NOTICE OF DEVIATION PURSUANT TO 10 CFR 21

Subject: NPKC-7-21A(N) Splice kit with possible compromised jacket seal

2. USING THIS ILLUSTRATION:

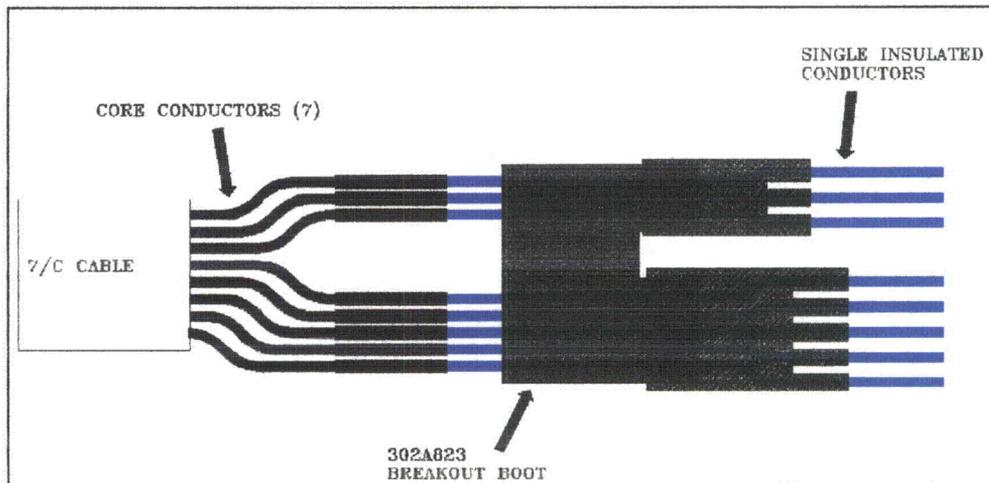
Determine if any splices were installed on single insulated conductors that have an outside diameter less than 0.18 inches.

2.1. If NOT, then the installed splices are still insulated, sealed and protected and therefore no corrective action or replacement is required.

2.2. If YES, Determine whether or not the cable jacket or the cable jacket seal is required for Environmental Qualification.

2.2.1. If YES, the splices should be removed and replaced. Notify TE Connectivity for replacement. (Telephone 800-327-6996)

2.2.2 If NOT, then verify the diameter of the seven core conductors to be greater than 0.11 inch. If they are equal to or greater than 0.11 inches, then the seven individual conductor splices are still insulated, sealed and protected and therefore not part of this notification. If they are less than 0.11 inches, the splices should be removed and replaced. Notify TE Connectivity for replacement. (Telephone 800-327-6996)
